DESIGN/DEVELOPMENT REVIEW COMMISSION
DESIGN REVIEW DISTRICT
EVALUATION SHEET
Case # 2

ADDRESS: 1222-1224 Taylor Street

NATURE OF REQUEST: Request for Certificates of Design Approval for renovations to an existing structure.

AS1.1

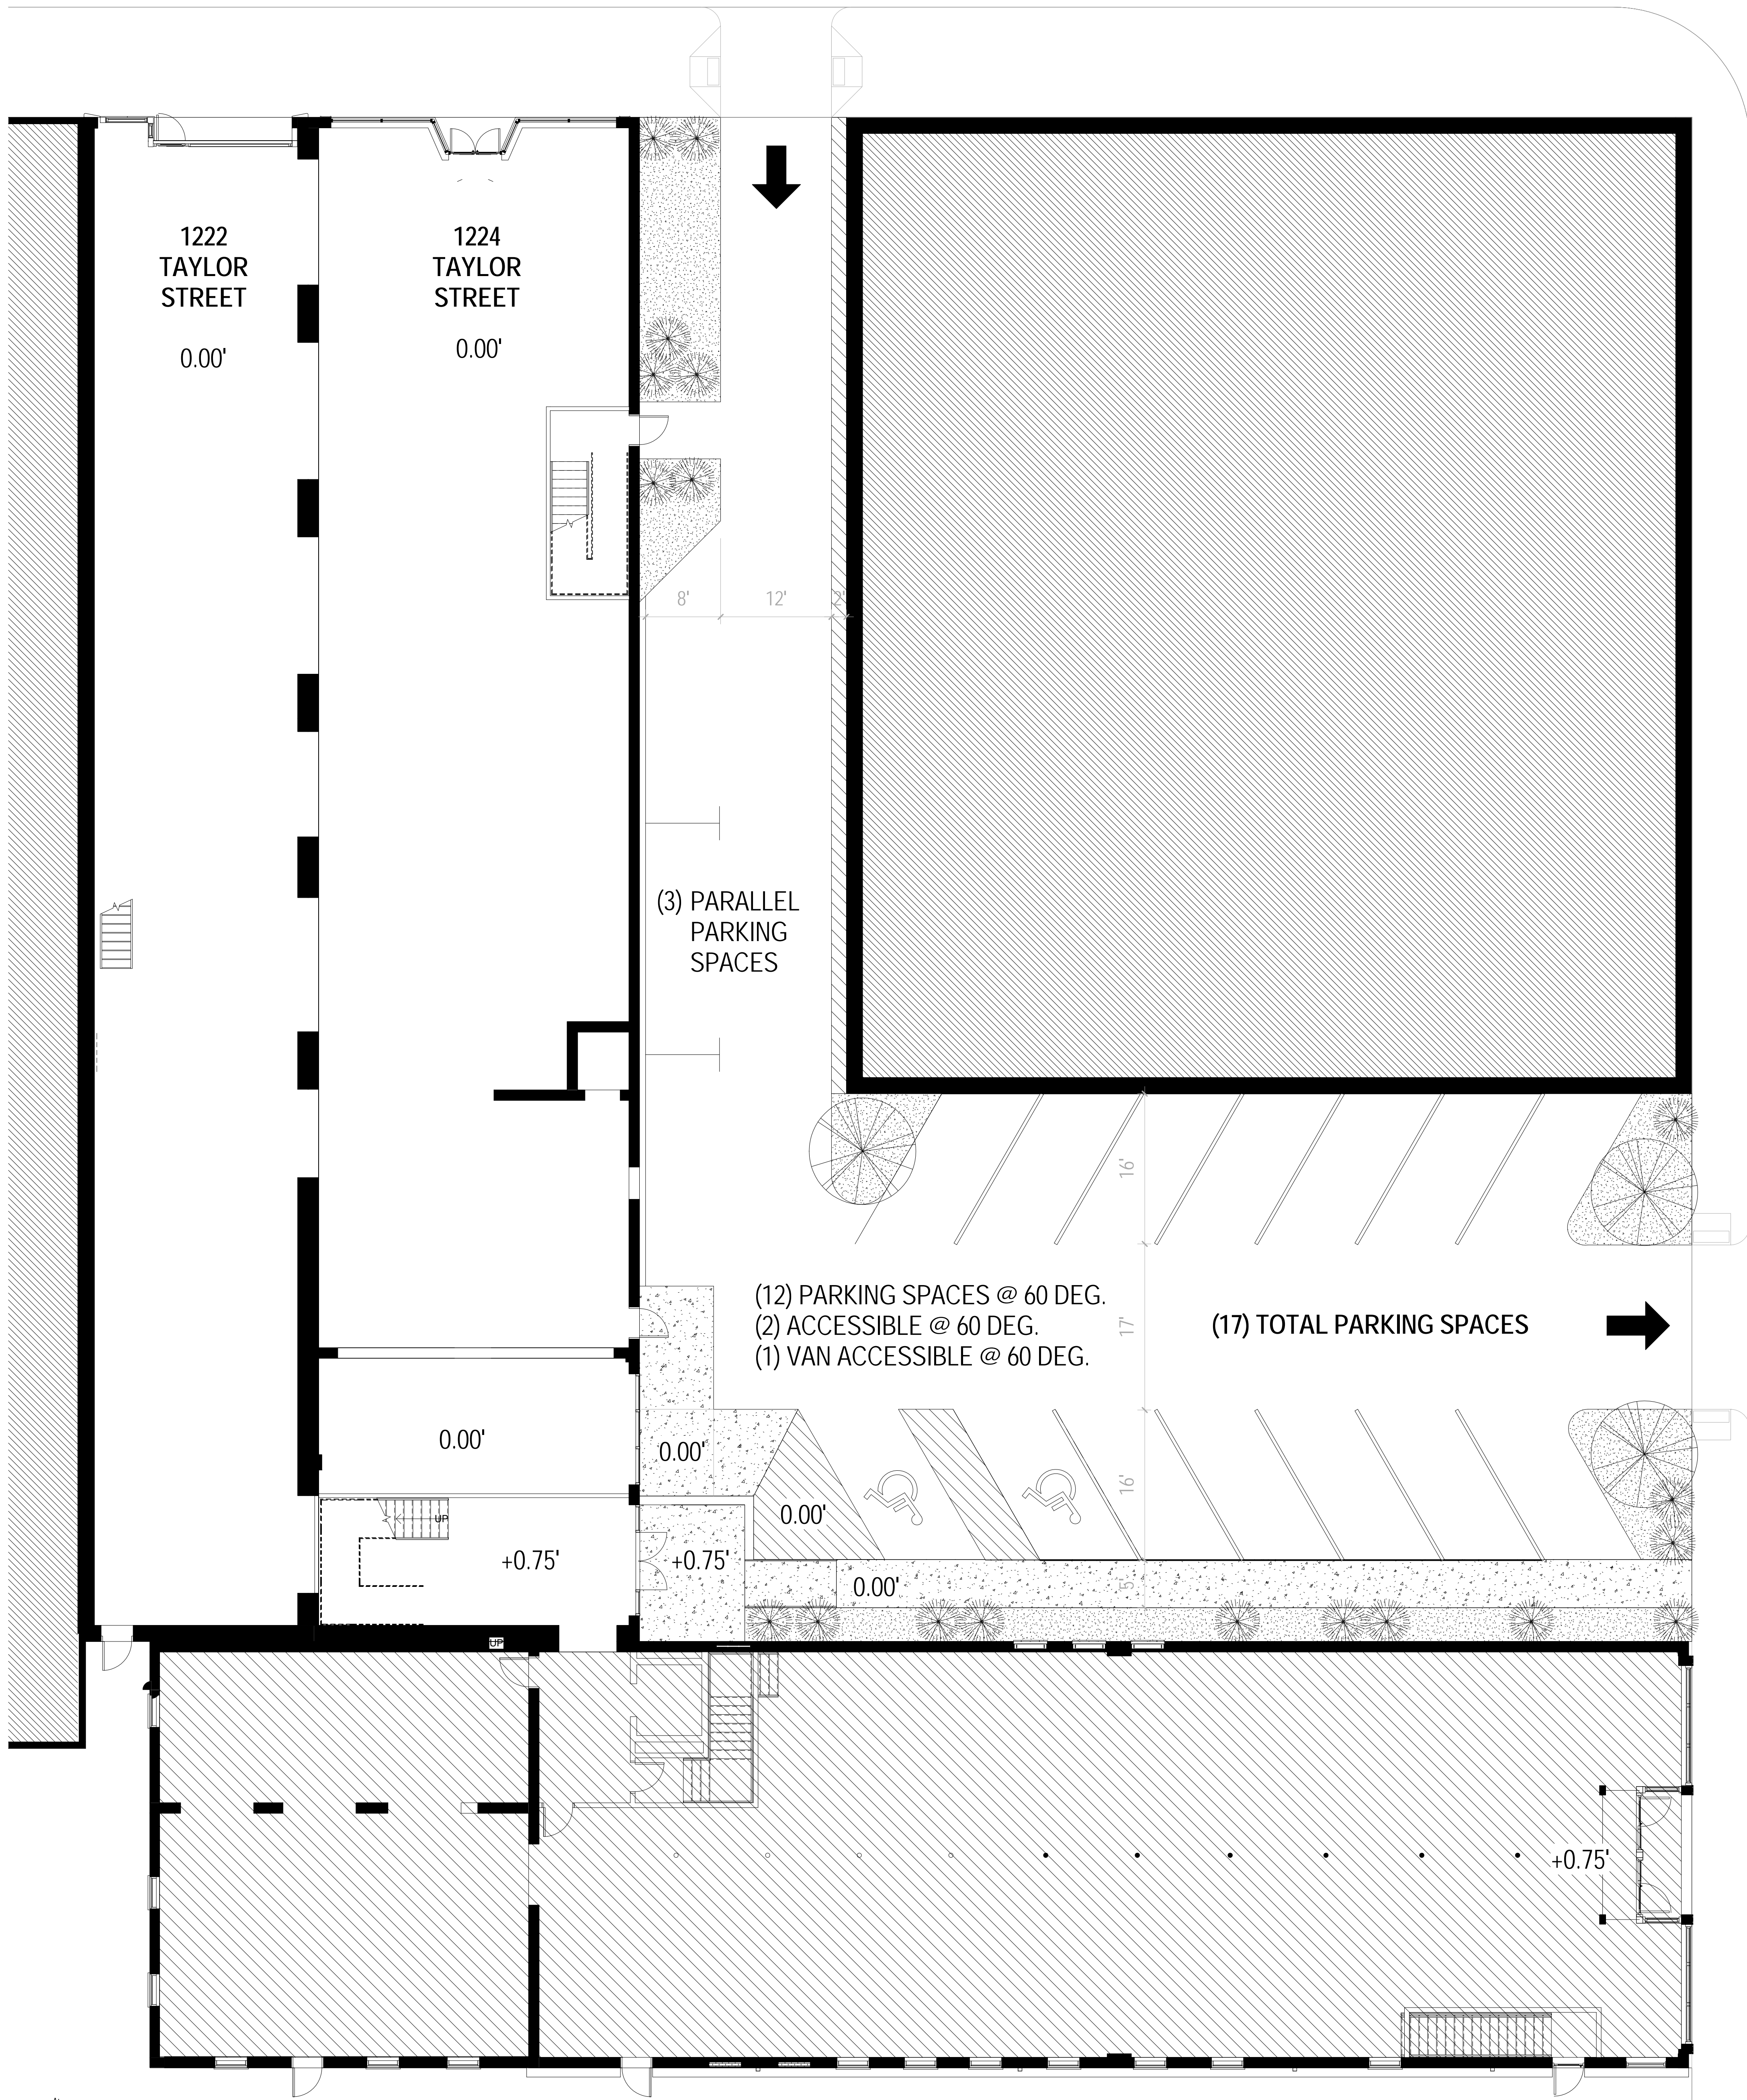
Storefront is being added to the southern end of the eastern façade, facing Sumter Street. As this is an existing building, the storefront ends up far back from the street. To provide pedestrian access, a sidewalk has been provided between the parking and the adjacent building. This pedestrian connection is important to keep pedestrians from walking through the parking lot.
